Planning & Zoning
Commission
Agenda

Site Plan for Mighty 8th Air Force Museum Phase II Expansion.

Re: National Museum of the Mighty 8th Air Force - Phase 2 - Specific Development Plans

Plans entitled National Museum of the Mighty 8th Air Force - Phase 2 - sheets C1-C14, L1, F1, and E1.0 dated 4/18/24.

CIVIL SITE LAYOUT

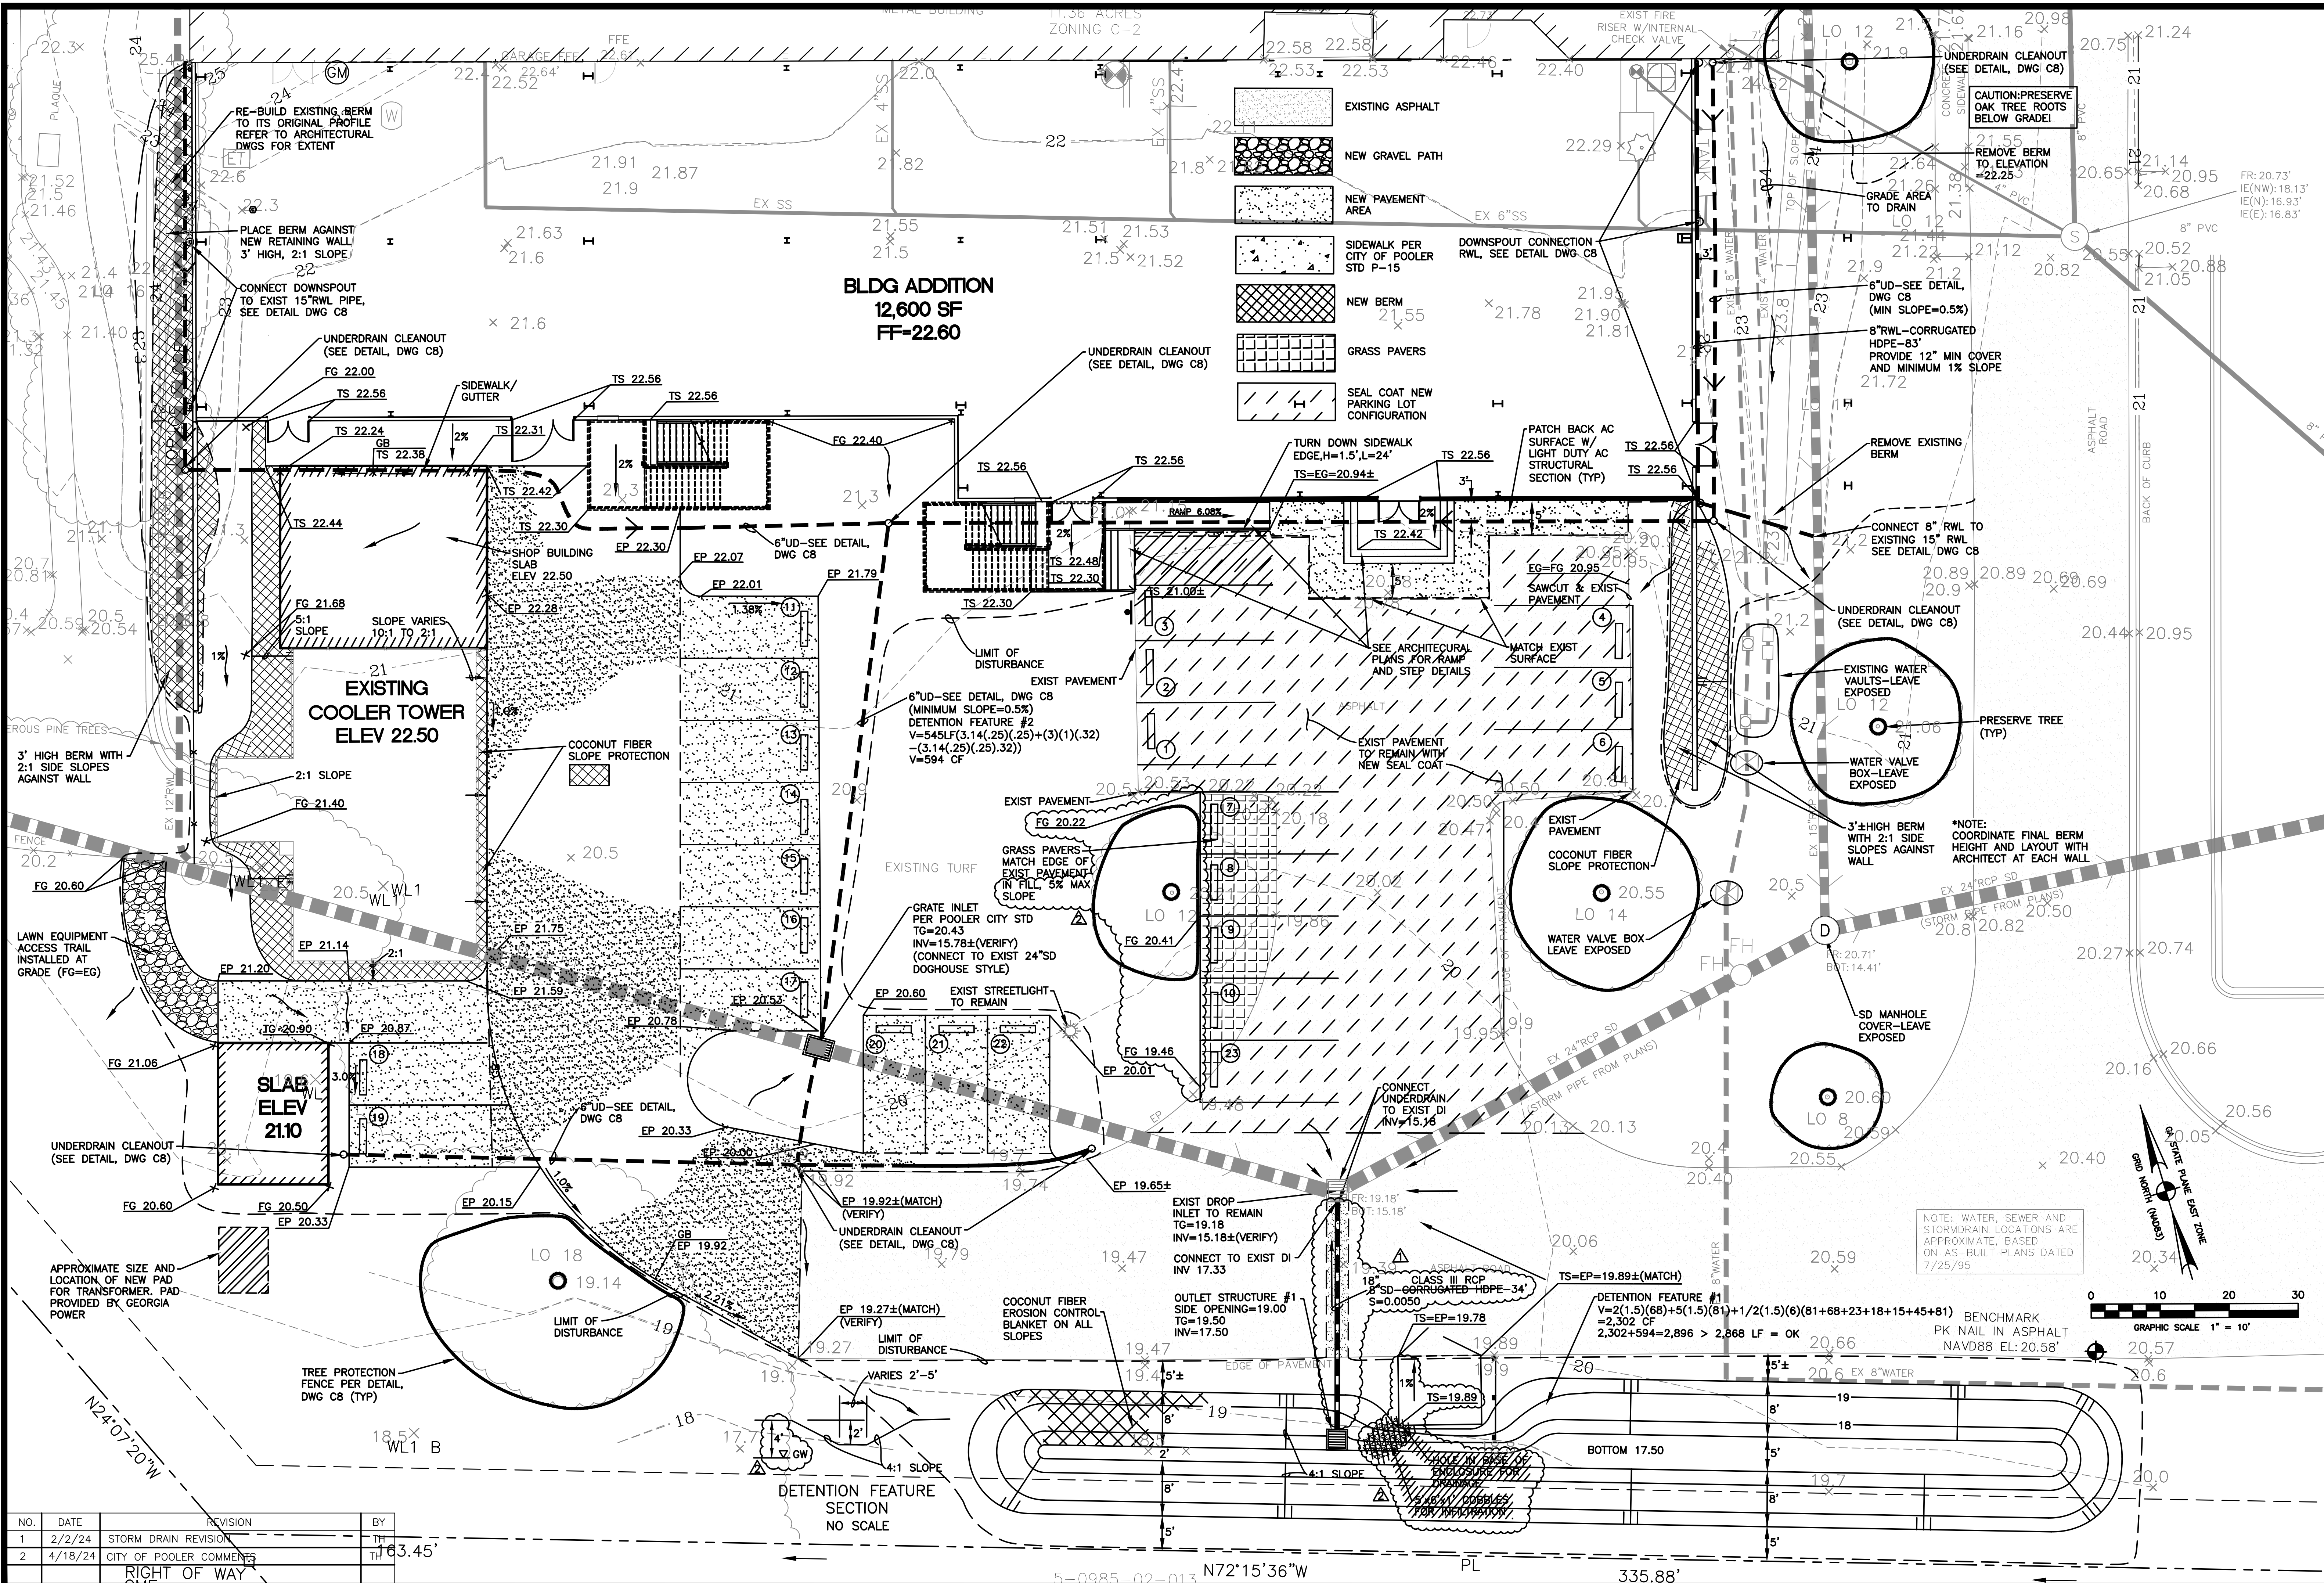
13. There are 2 asphalt section details provided in the drawings, however, it is not clear where each of the two sections are applicable on the proposed paving plans. **We have added notations to the layout plan (C3) to clarify.**
